AGENDA
PLAN COMMISSION MEETING
Thursday, January 6, 2022 at 7:00 p.m.
Jackson Municipal Complex
Village Board Room
N168 W19851 Main Street
Jackson, WI 53037

1. Call to Order and Roll Call
2. Approval of Minutes for the Plan Commission Meeting of December 2, 2021
3. Conditional Use Amendment – Morning Star Lutheran Church – Early Childhood Learning Building Addition – N171W20131 Highland Road
4. Citizens to Address the Plan Commission
5. Adjourn

Project: Morning Star Early Childhood Center Addition
N171 W20131 Highland Rd
Jackson, WI 53037

Plan Commission December Meeting – January 6, 2022

C2.1

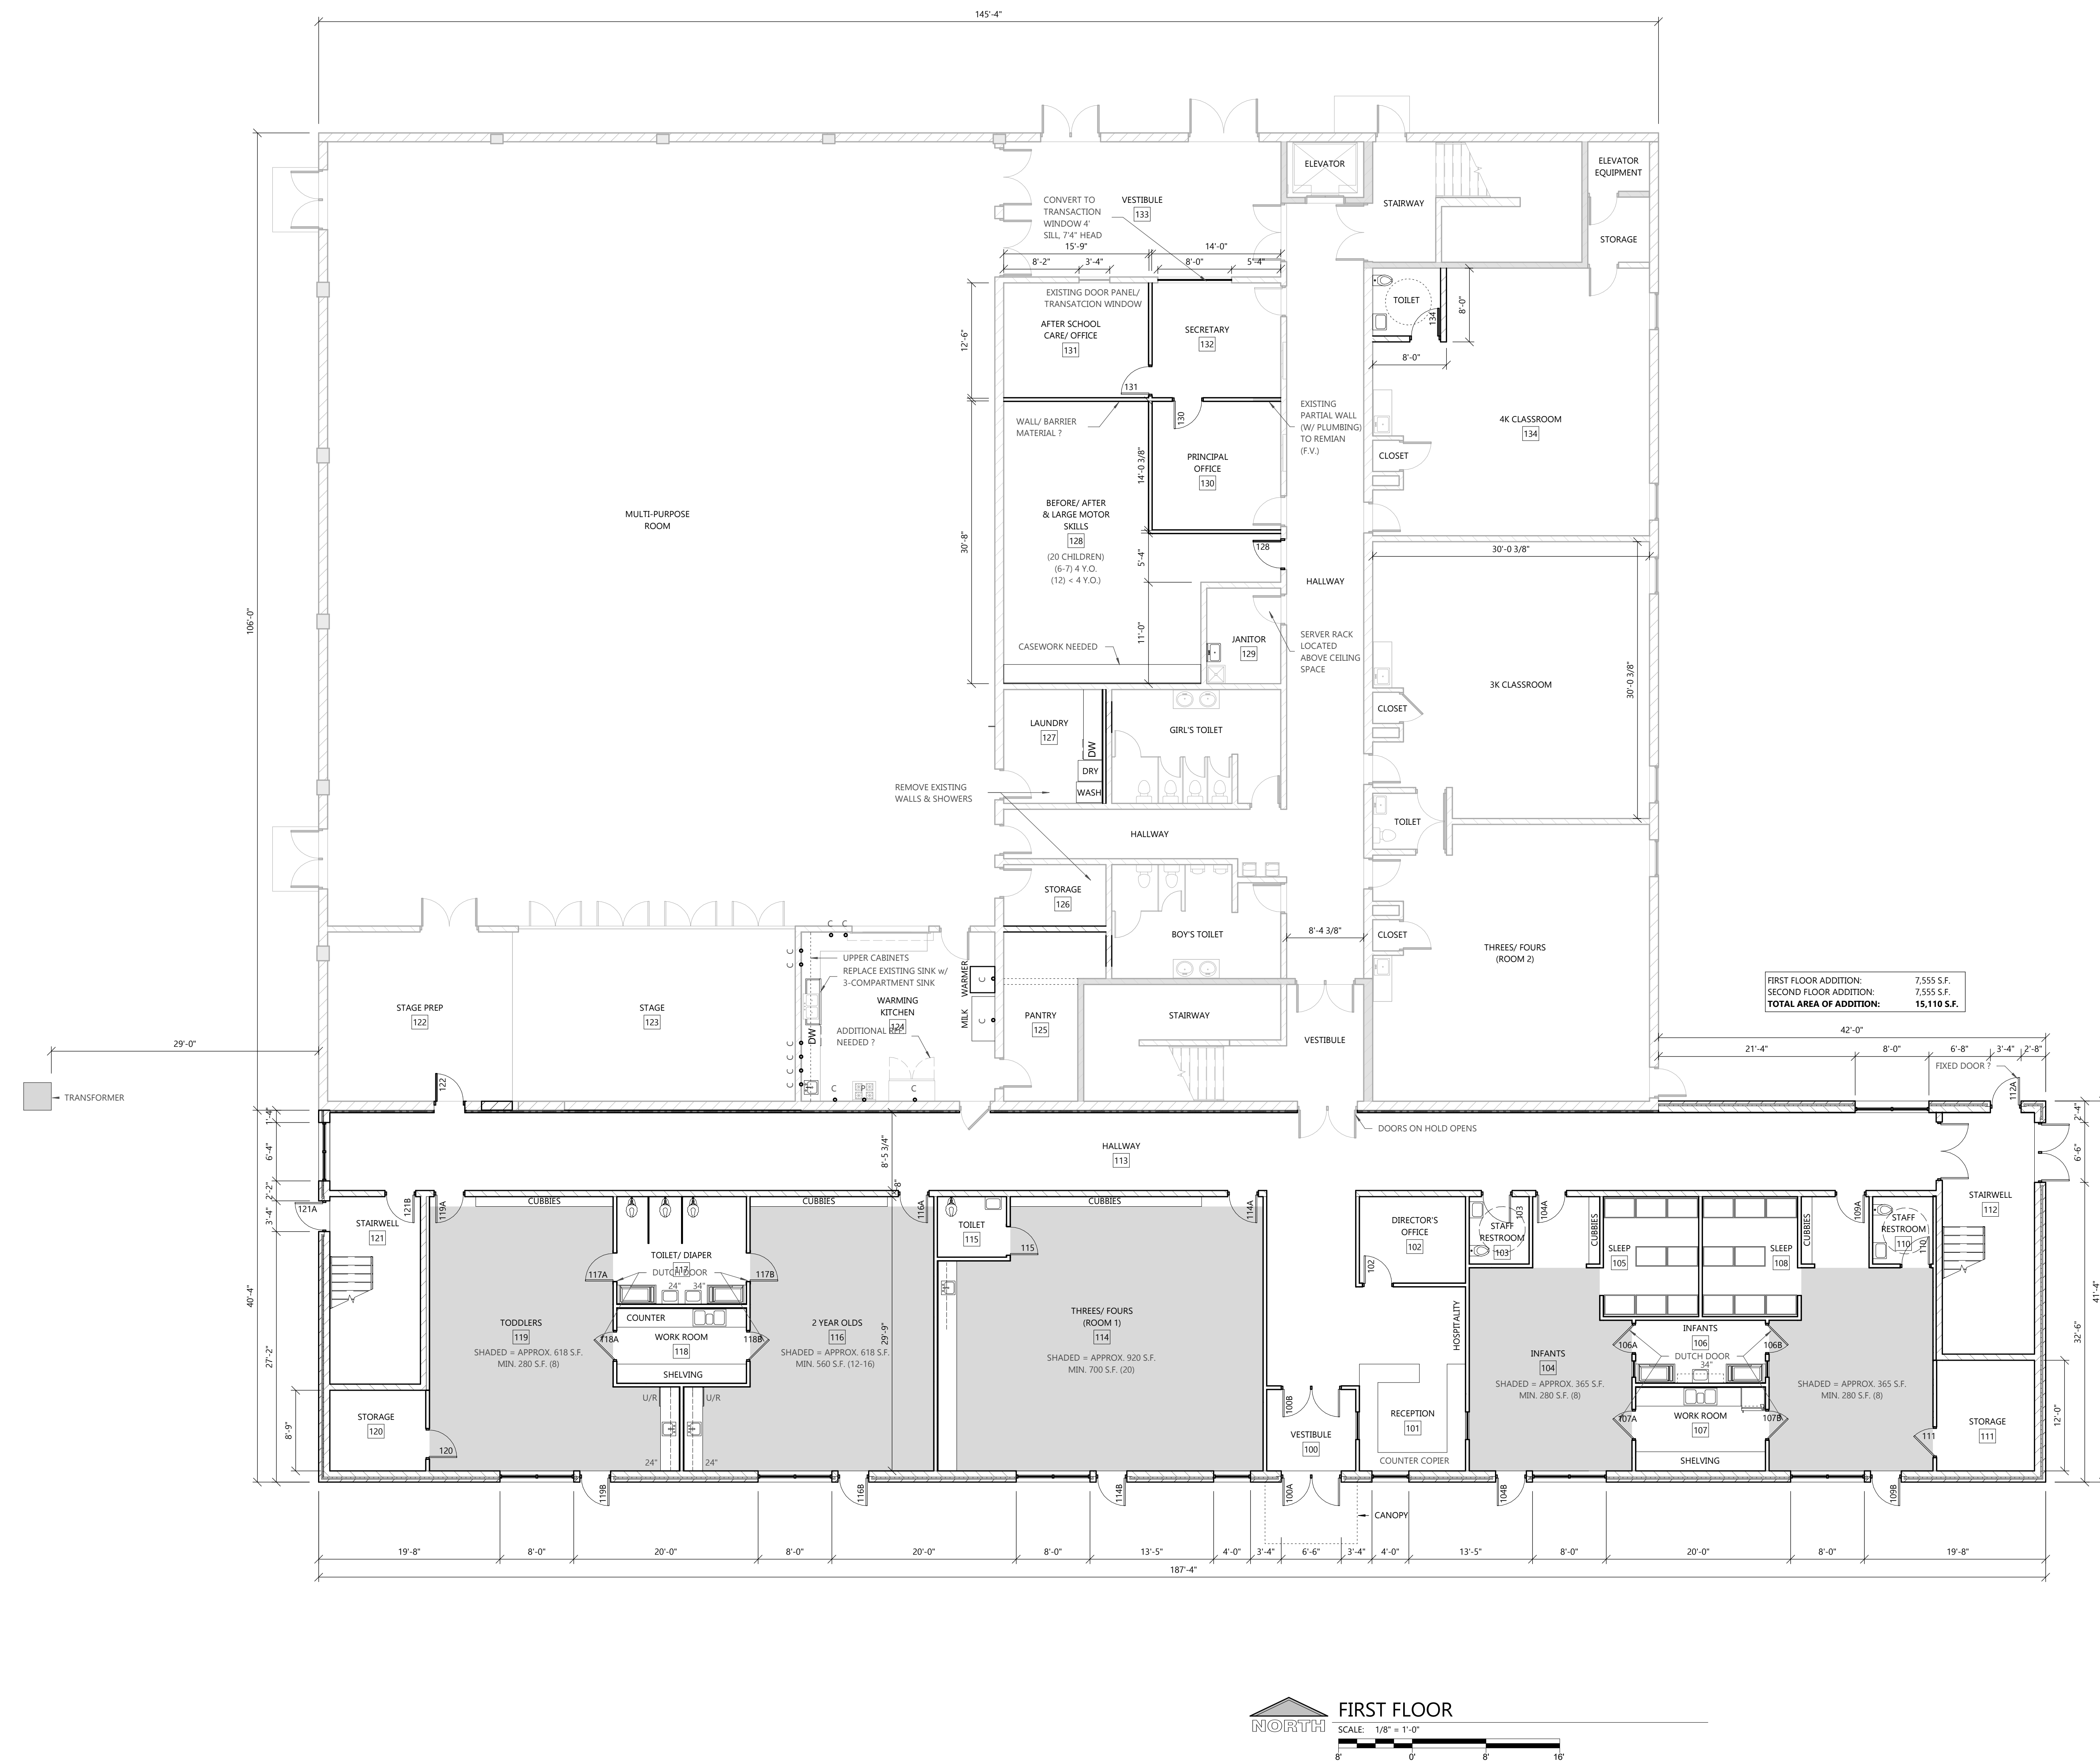
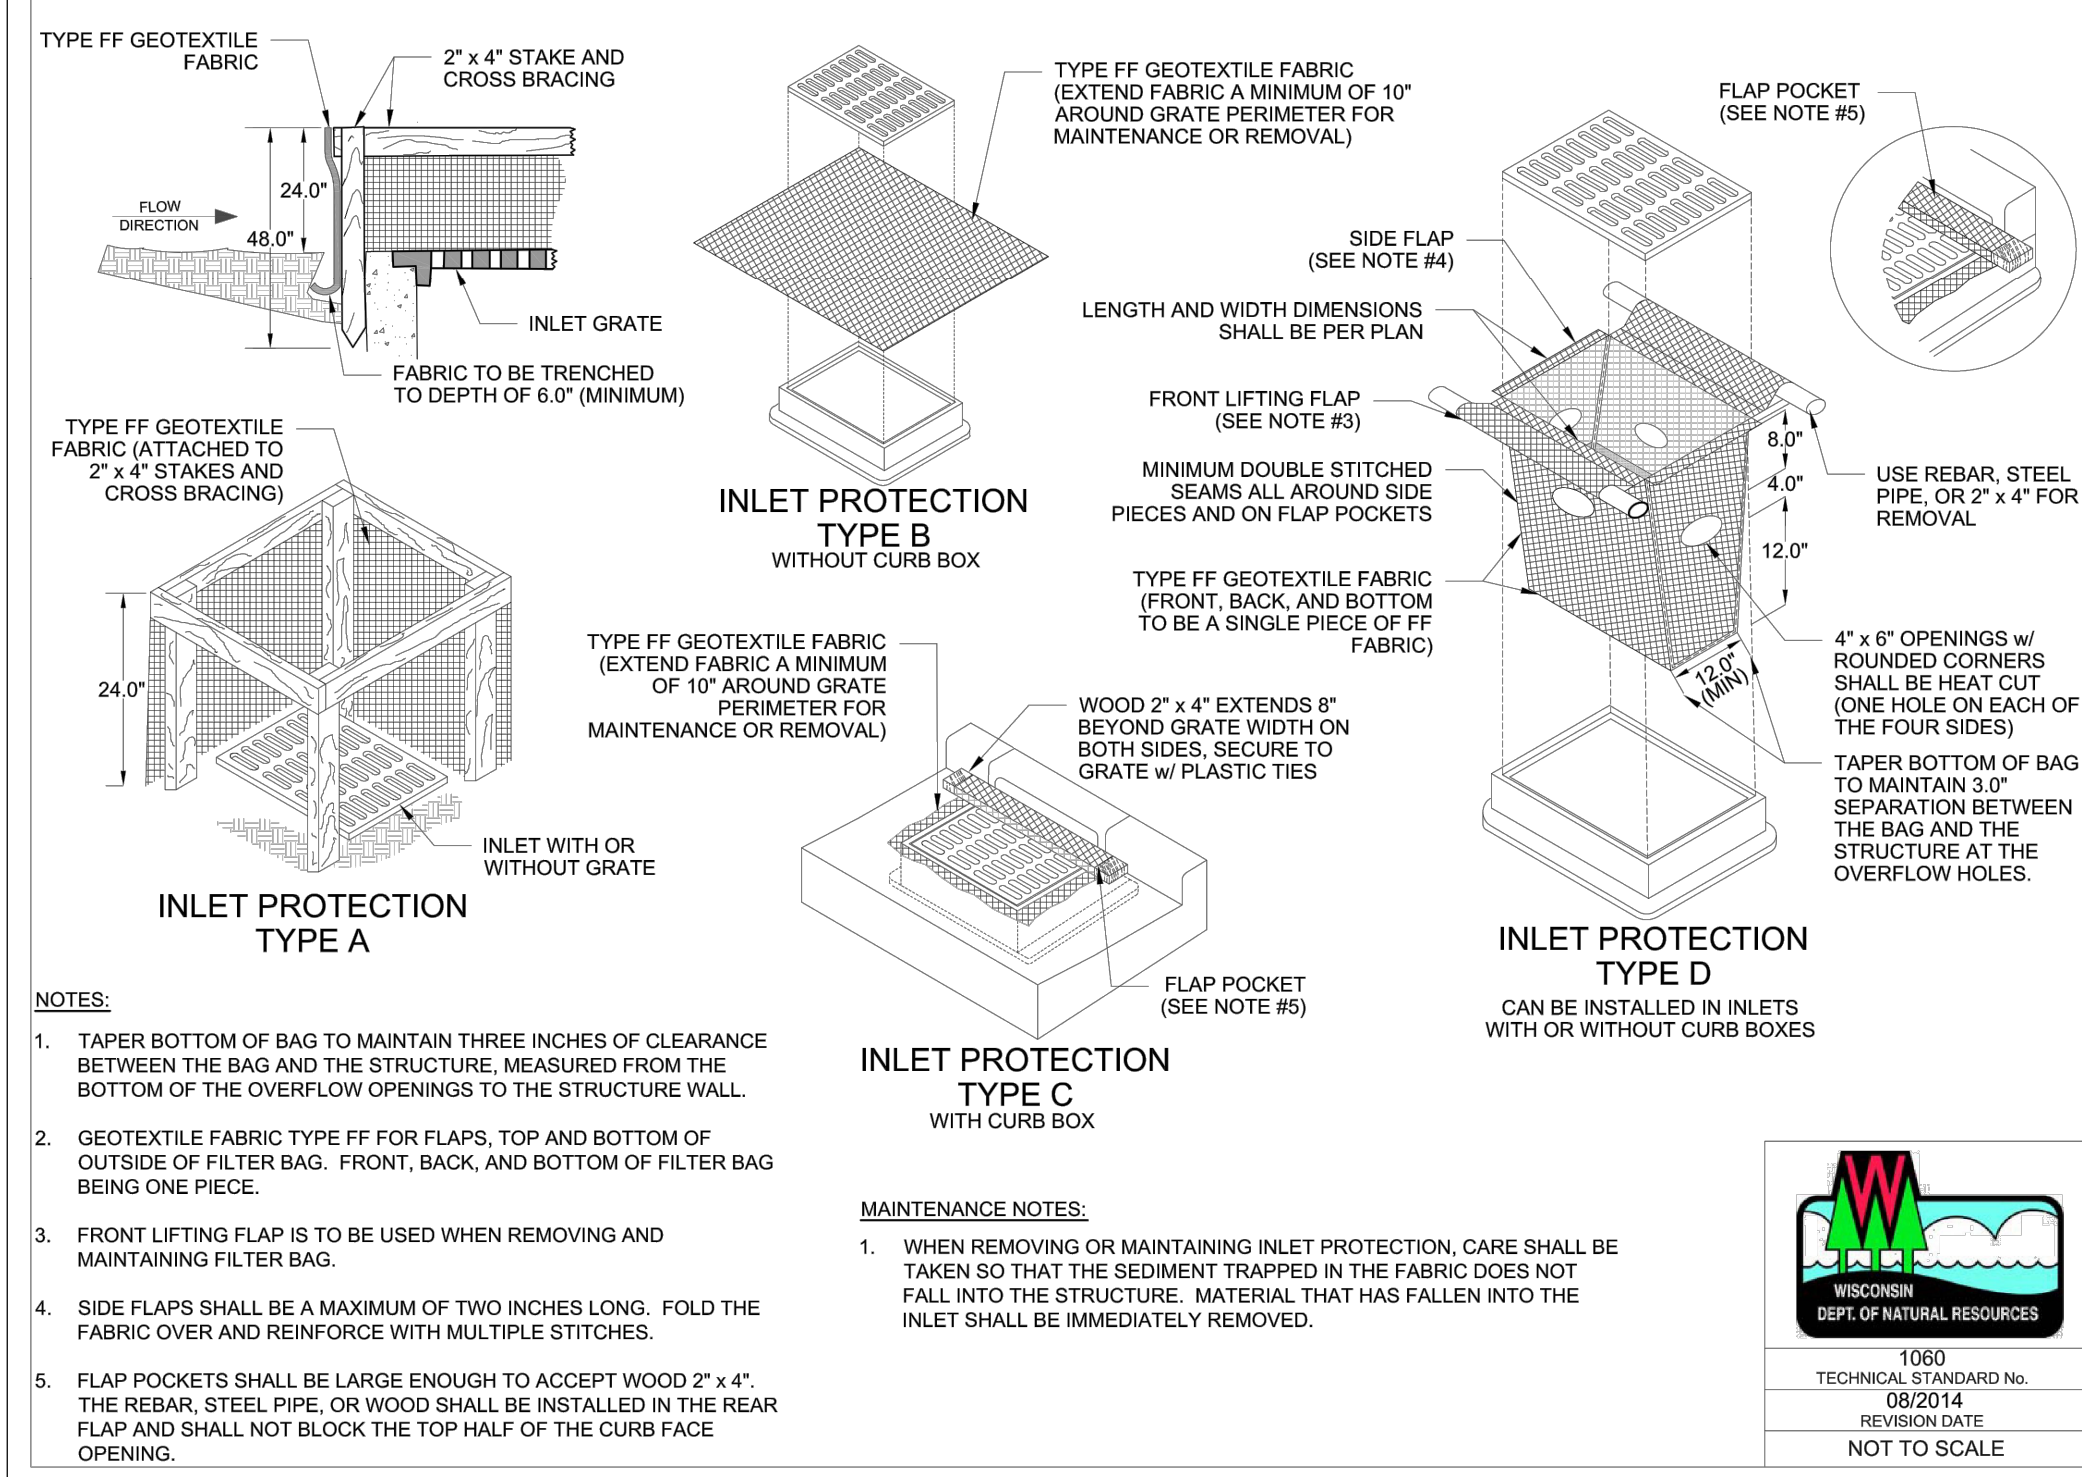
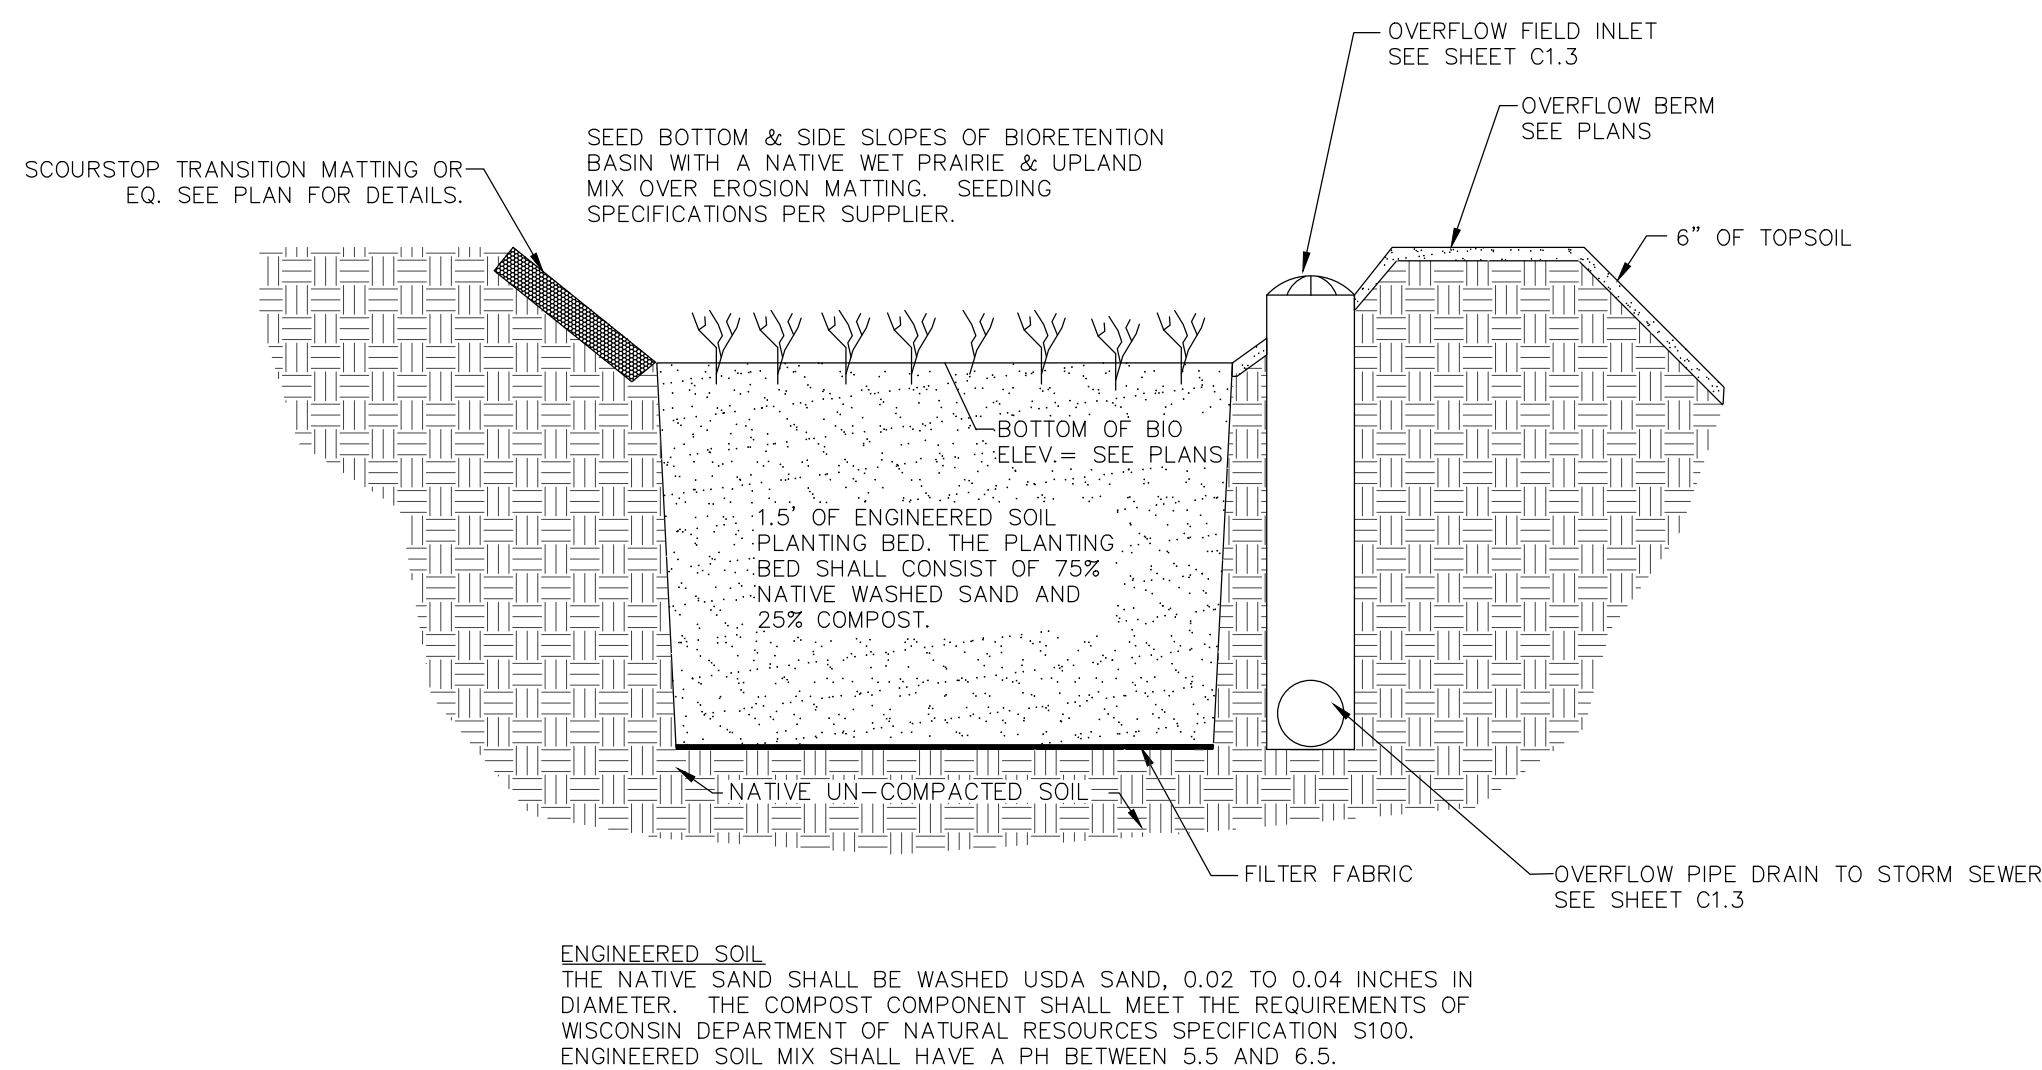
- The Stormwater Management Plan with date of December 8, 2021 per the design of maximum extent practicable approach is approved as submitted. Per the design, a new bio-retention area with be created and Dry Pond C will be expanded to accommodate the new stormwater run-off.
- The building addition will cause an increase to the annual water usage to the existing building, recommend after a year of occupancy the water usage shall be calculated to determine if additional REUs have been generated for increase charge of Sewer Connect Fee and Water Impact Fee.
